RS-17-130

Quad Cities Nuclear Power Station, Units 1 and 2  
Renewed Facility Operating License Nos. DPR-29 and DPR-30  
NRC Docket Nos. 50-254 and 50-265

Subject: Additional Information Regarding Request for License Amendment to Revise Technical Specifications Section 5.5.12 for Permanent Extension of Type A and Type C Leak Rate Test Frequencies

**QC-LAR-05, "Quad Cities ILRT RAI Round 2 Response"**

FIGURE 5-4  
ECCS-NPSH FAILURE IMPACT TO ZZ-FAIL

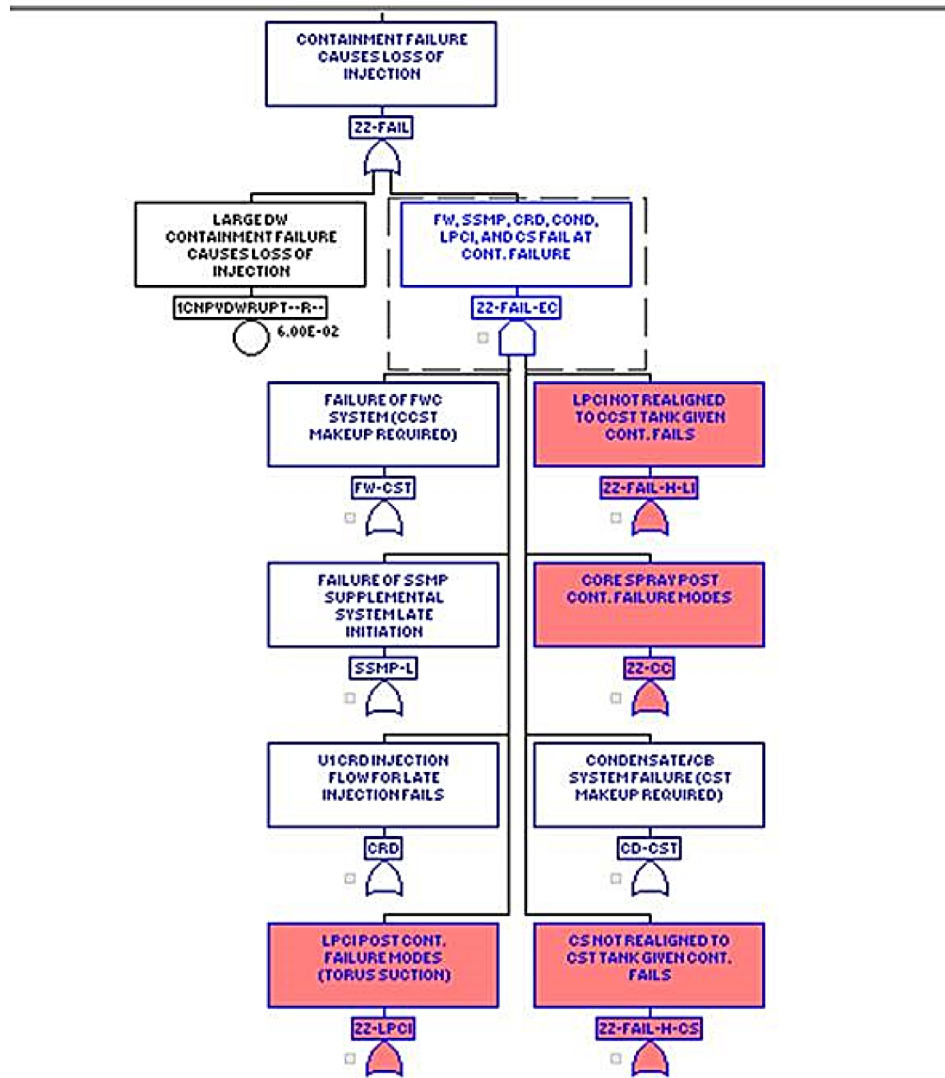
The RAI response attempts to explain the PRA modeling for scenarios “post containment failure” and for scenarios with “successful pool venting” in Figures 5-4 and 5-5. Since the containment would already be failed due to the postulated pre-existing containment leak, further PRA modeling appears unnecessary and the application of the model described in Figure 5-1 to those post containment failure scenarios may result in a reduction in the risk estimate. The RAI response also states that for “successful pool venting,” only sources outside the containment are credited. Clarify how the PRA model described in response to RAI 5 correctly captures the risk impact from accident scenarios “post containment failure” and those with “successful pool venting.”

In the PRA model, the loss of NPSH fails CS and RHR (from the suppression pool) for RPV injection early in the event tree sequences. This failure is maintained throughout the accident sequences, such as in consideration of RPV injection later in a given sequence. Figures 5-4 and 5-5 were included in the previous RAI response for completeness purposes. These figures

demonstrate that upon loss of NPSH due to a pre-existing containment failure, the CS and RHR RPV injection systems taking suction from the suppression pool are failed throughout the model, including in the model logic that assesses the available RPV injection systems later in sequences during consideration of available RPV injection post-containment failure due to containment over-pressure failures. Containment overpressure scenarios and containment vent scenarios are further discussed below.

The ECCS pumps taking suction from the suppression pool are failed in the model prior to containment over-pressure failure and the pumps are not credited for post-containment failure RPV injection. This is reflected in Figure 5-4 under gate ZZ-FAIL-EC which considers RPV injection sources that may be available if not disrupted by a containment over-pressure failure. Under this gate RHR LPCI and CS, when taking suction from the suppression pool, are shown as failed (due to earlier loss of SPC, SDC and NPSH associated with pre-existing containment leakage). It is additionally noted that no credit is applied in the model for the potential that the postulated ILRT pre-existing leakage could mitigate a containment over-pressure condition and prevent a containment rupture and the associated physical disruptions of injection lines.

6. Figure 5-4 shows the logic for RPV injection post-containment failure. As discussed previously, this logic addresses random failure of systems (under gate ZZ-FAIL-EC) and failure from a large DW containment rupture failure that could

cause loss of injection from all sources. A large DW containment failure assumes the potential exists for a catastrophic failure, and this failure would not be associated with a pre-existing leak. Figure 5-4 also shows the impact of a loss of LPCI and CS caused by loss of NPSH (as represented by ECCS-NPSH logic failure). FW, SSMP and CRD random failure logic is not impacted by ECCS-NPSH gate failure.
